SHEARON HARRIS NUCLEAR POWER PLANT  
NRC DOCKET NO. 50-400  
OPERATING LICENSE NPF-63  
REQUEST FOR LICENSE AMENDMENT  
BORON DILUTION/SLIDING SHUTDOWN MARGIN

REVISED TECHNICAL SPECIFICATION PAGES

FIGURE 3.1-1  
 SHUTDOWN MARGIN VERSUS RCS BORON CONCENTRATION, MODES 3, 4, AND 5

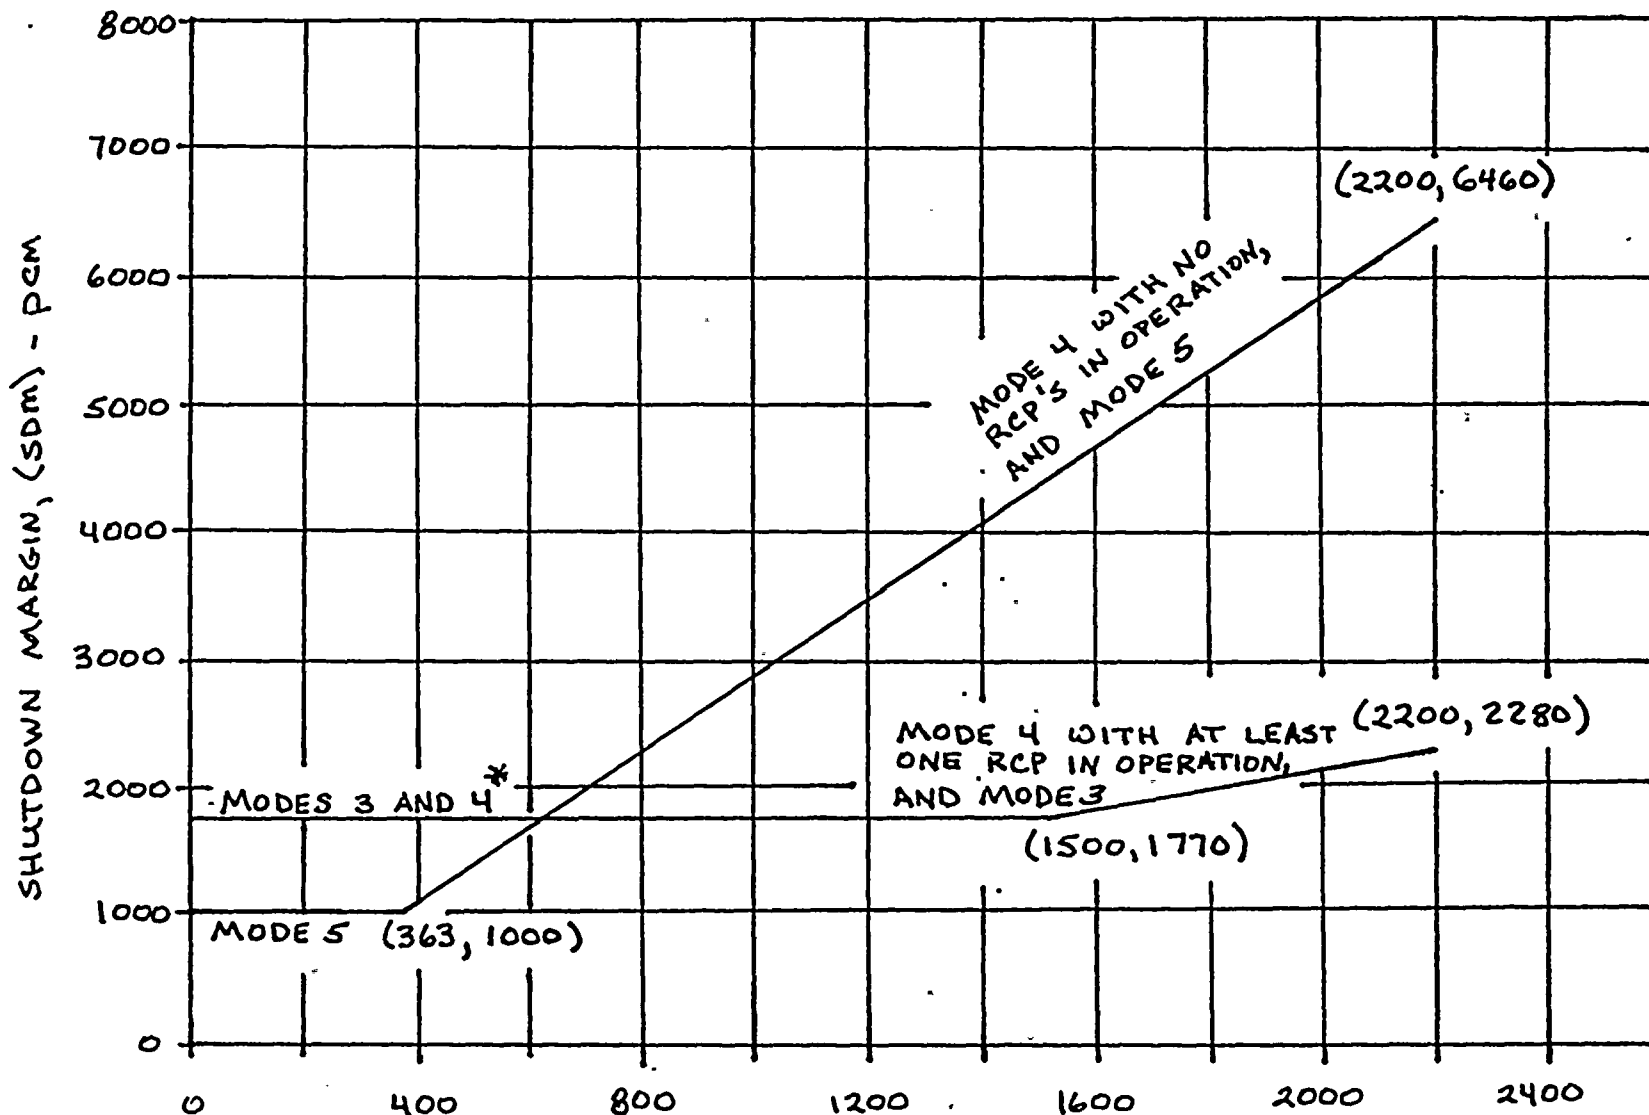
3.1.1.2 The SHUTDOWN MARGIN shall be greater than or equal to ~~2000 ppm~~.

APPLICABILITY: ~~MODE 5~~ *Nodes 3, 4, and 5*

*the limit shown in Figure 3.1-1*

With the SHUTDOWN MARGIN less than ~~2000 ppm~~ <sup>the required value</sup> immediately initiate and continue boration at greater than or equal to 30 gpm of a solution containing greater than or equal to 7000 ppm boron or equivalent until the required SHUTDOWN MARGIN is restored.

4.1.1.2 The SHUTDOWN MARGIN shall be determined to be greater than or equal to ~~2000 ppm~~ *the required value*:

Figure 3.1-1 must be used with a curve giving the required shutdown boron concentrations for various temperatures as a function of core burnup. This cycle dependent relationship is provided for each cycle in the plant Curve Book. From the Curve Book, a required boron concentration that will provide adequate SHUTDOWN MARGIN can be determined and this concentration may be used to enter Figure 3.1-1 to determine the specific required SHUTDOWN MARGIN for that condition.

2  
**FIGURE 3.1-X**  
**ROD GROUP INSERTION LIMITS VERSUS THERMAL POWER**  
**THREE-LOOP OPERATION**

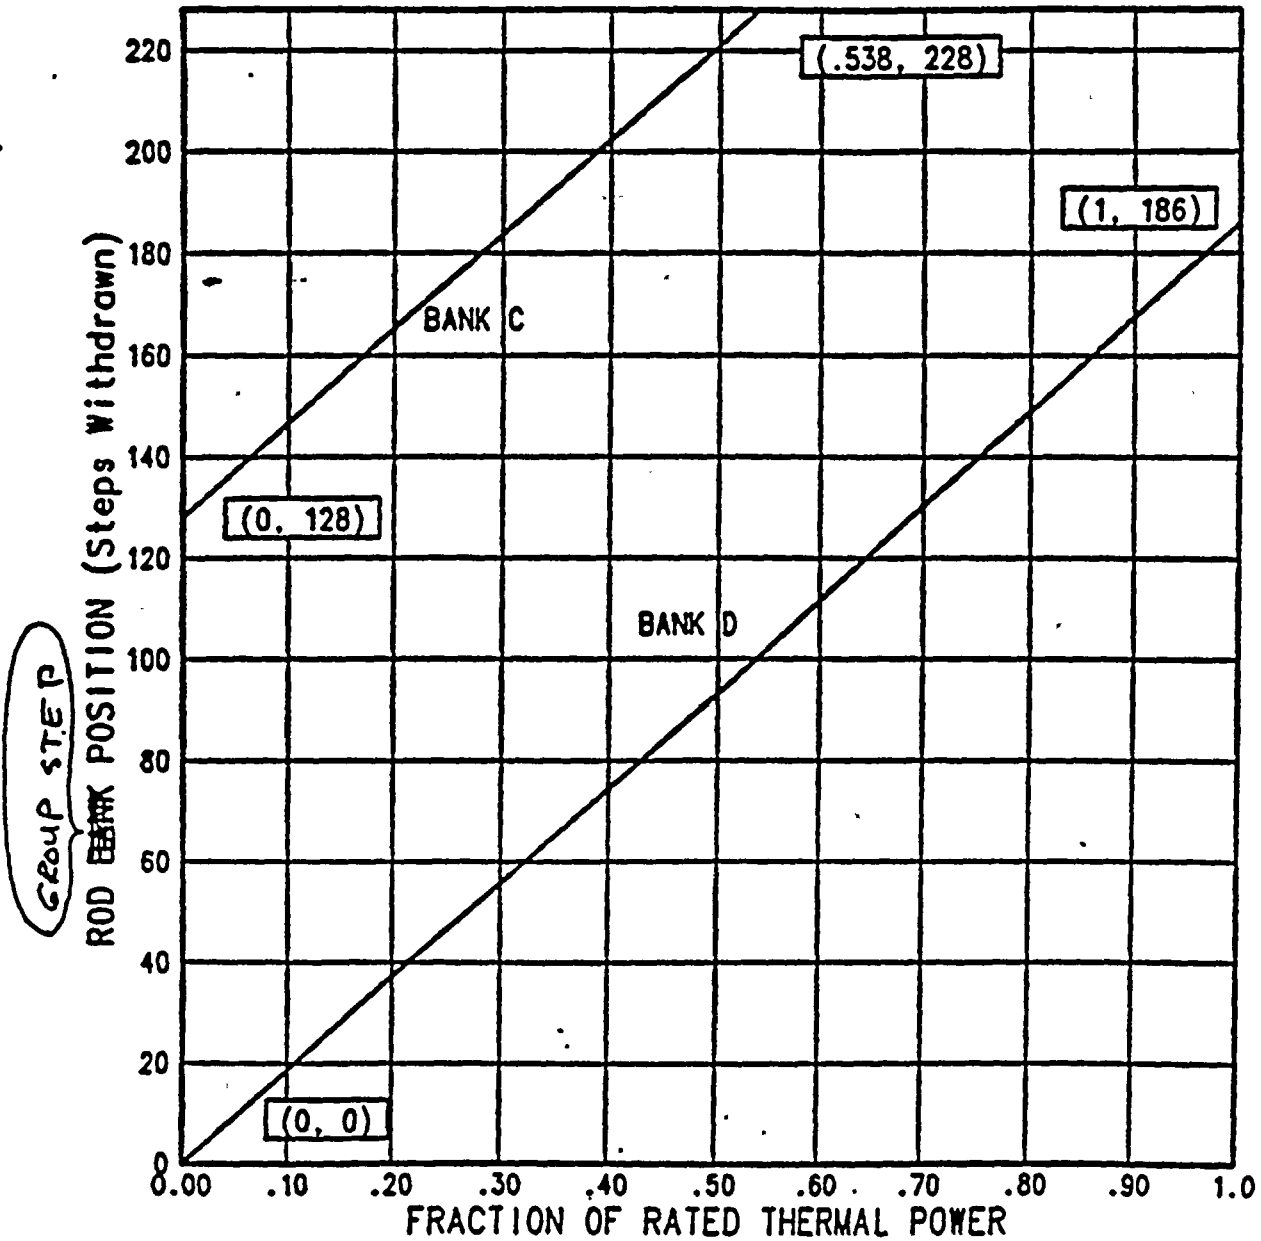
3.1.3.6 The control banks shall be limited in physical insertion as shown in Figure ~~3.1-1~~.

~~3.1-1~~  
3.1-2

- a. Restore the control banks to within the limits within 2 hours, or
- b. Reduce THERMAL POWER within 2 hours to less than or equal to that fraction of RATED THERMAL POWER which is allowed by the bank position using Figure ~~3.1-1~~, or  
3.1-2
- c. Be in at least HOT STANDBY within 6 hours.
